Back-up Plan development for the ePIC Tracker

Matt Posik, Ernst Sichtermann

Context

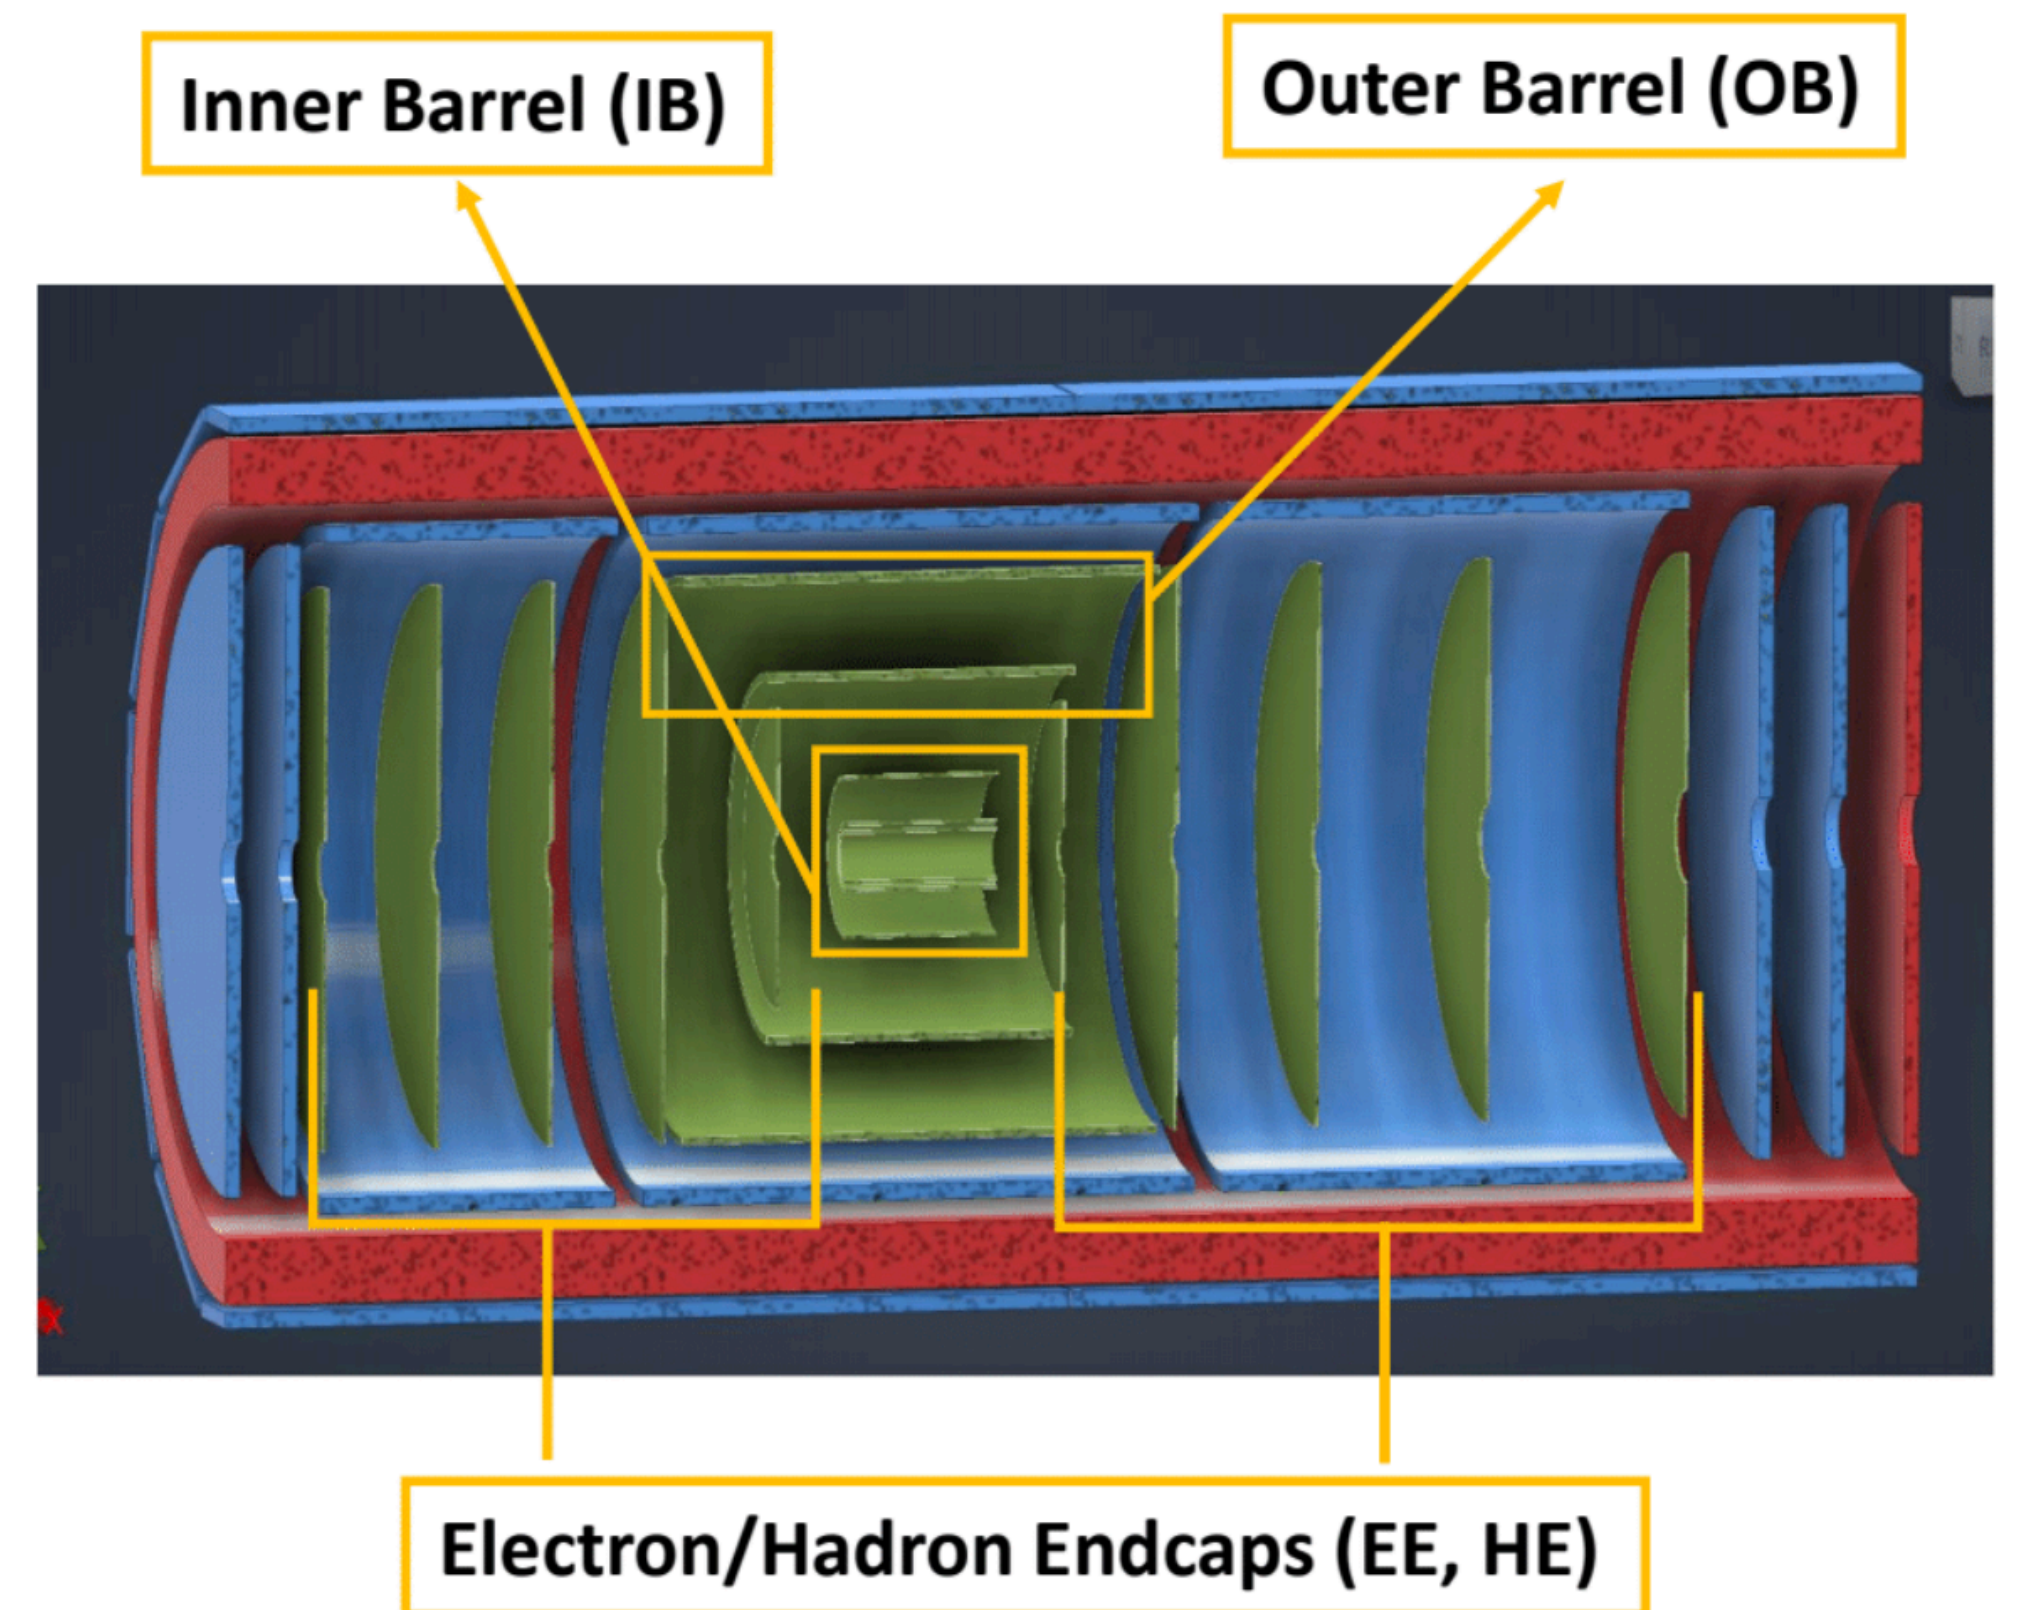
- ITS3 technology works with a timeline compatible with the EIC project timelines, but the EIC-LAS (“fork”) incurs delays that make its timeline incompatible with the EIC project timelines,
- ITS3 technology works but delays are incurred that make its timeline in ePIC incompatible with the EIC project timelines.

- The disks in the Electron and Hadron Endcaps are replaced with MPGD disks derived from the disks of the outer MPGD tracker; nominally, this will then result in 7 (near-)identical MPGD disks on each side,
- The two Outer Barrel layers are replaced with MPGD barrel layers derived from the outer MPGD tracker, specifically its inner (curved) uRWELL layer.

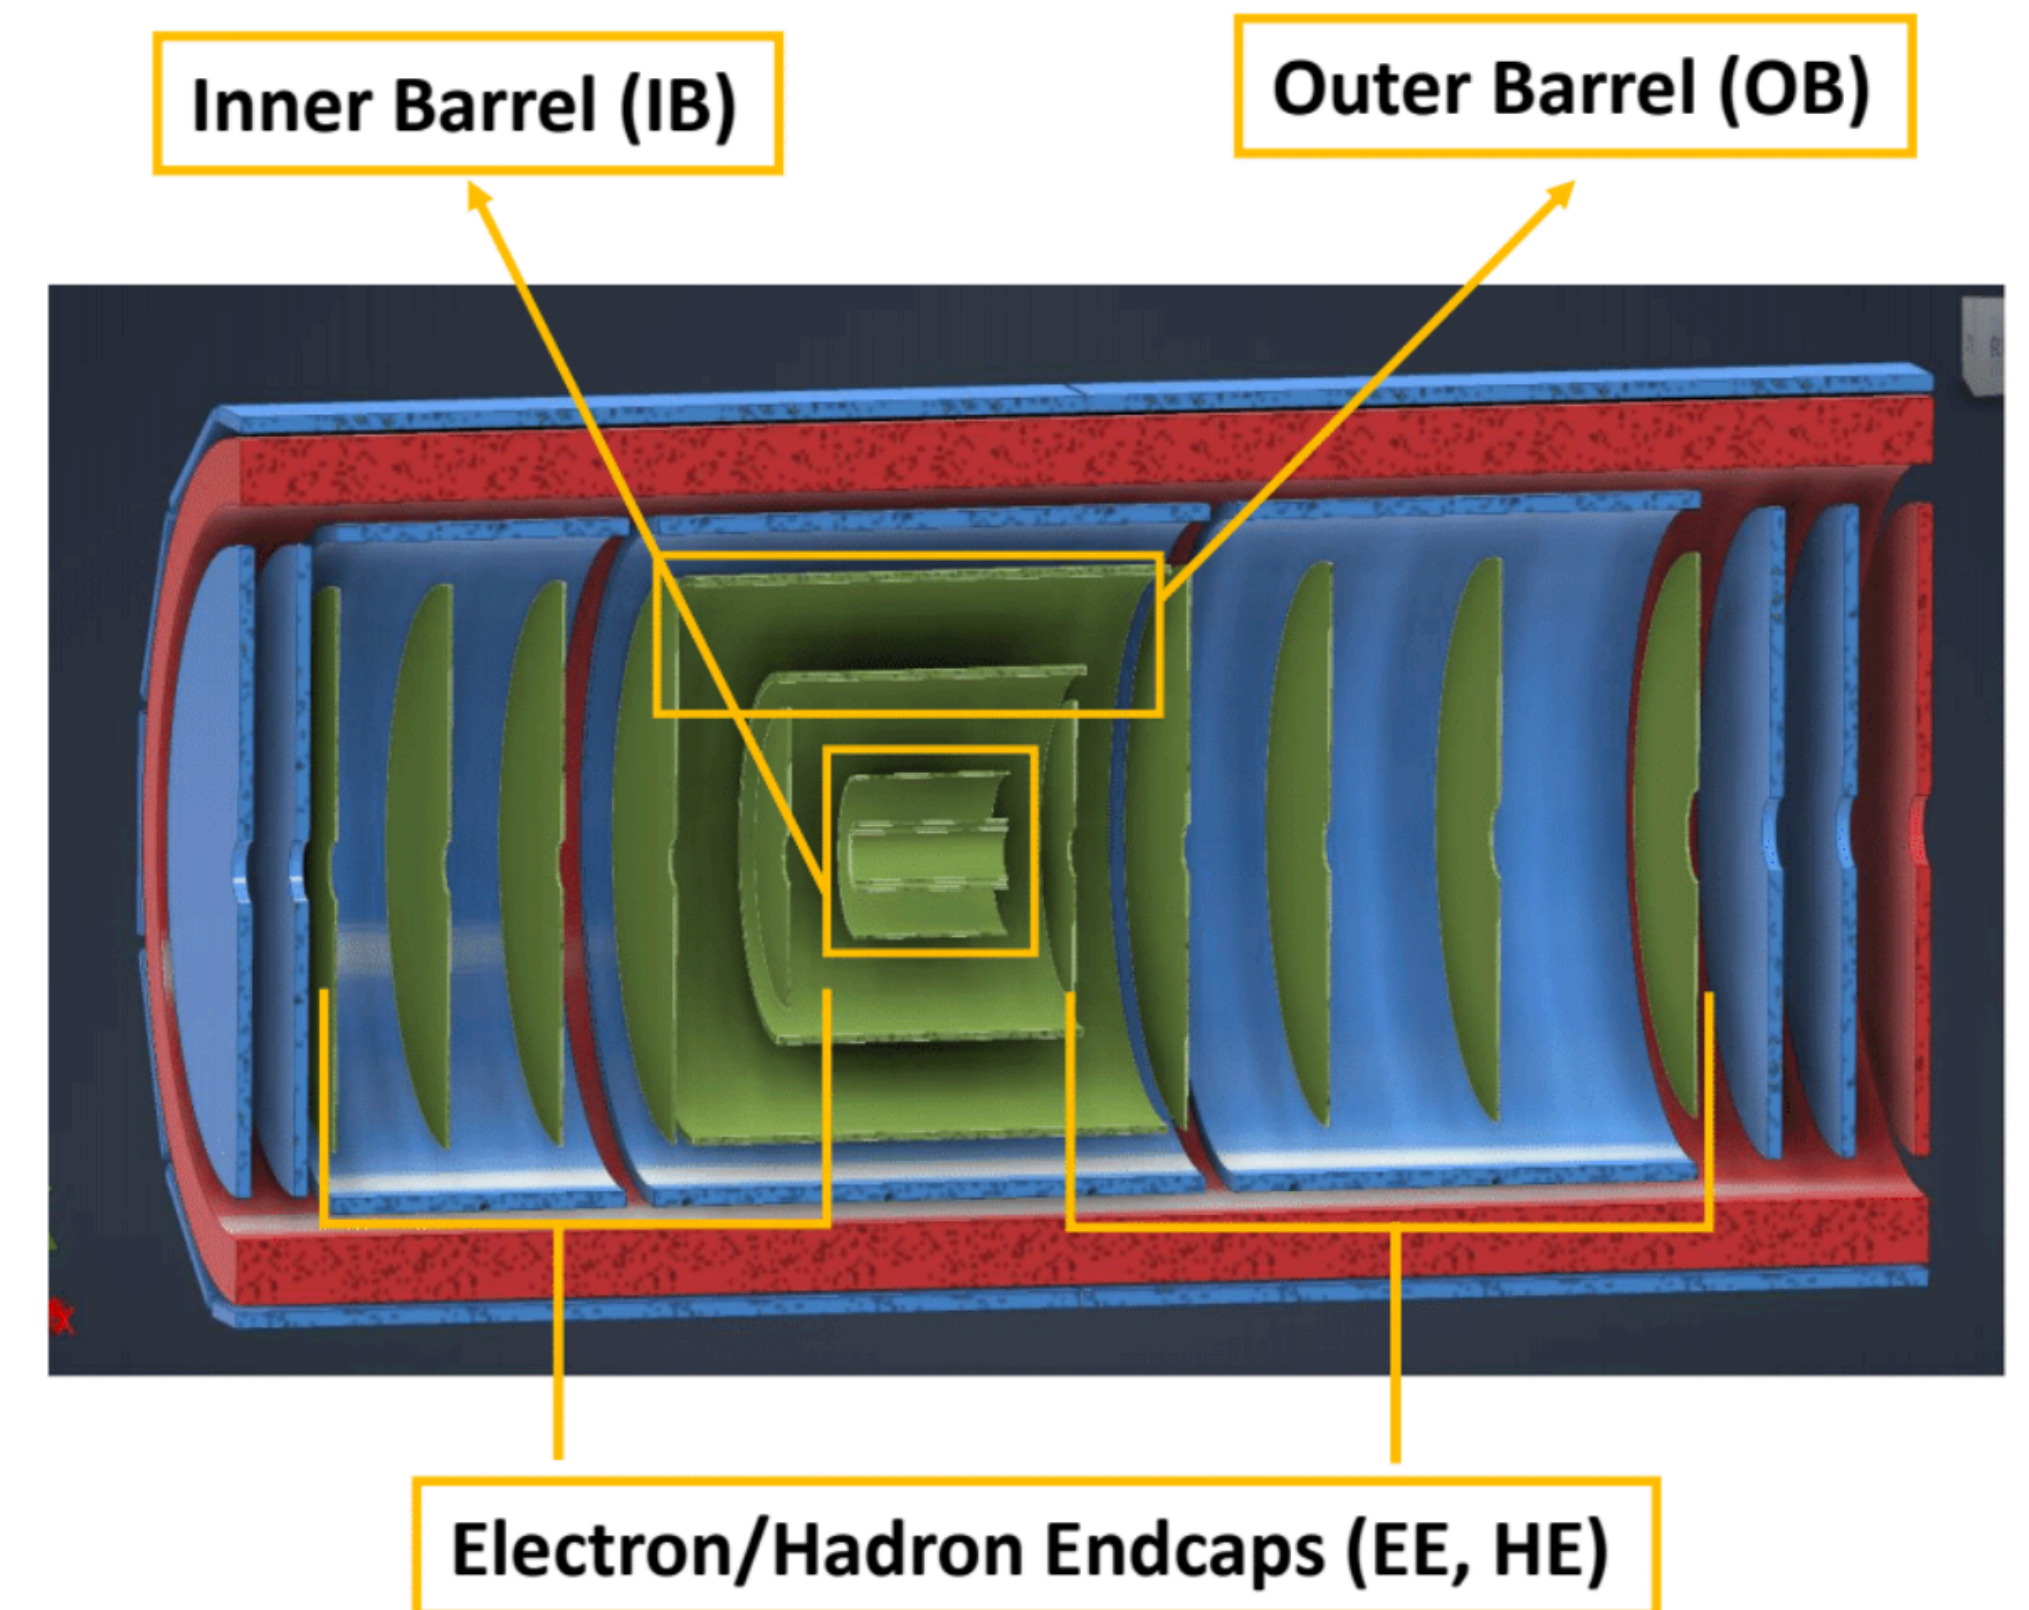
- ITS3 technology works but delays are incurred that make its timeline in ePIC incompatible with the EIC project timelines,

- The Inner Barrel is replaced with two or three layers based on the existing ITS2 sensor, as used in ALICE and sPHENIX without EIC-specific modifications,
- The Outer Barrel and Endcaps are replaced with MPGD barrel and disks as in the first branch point.
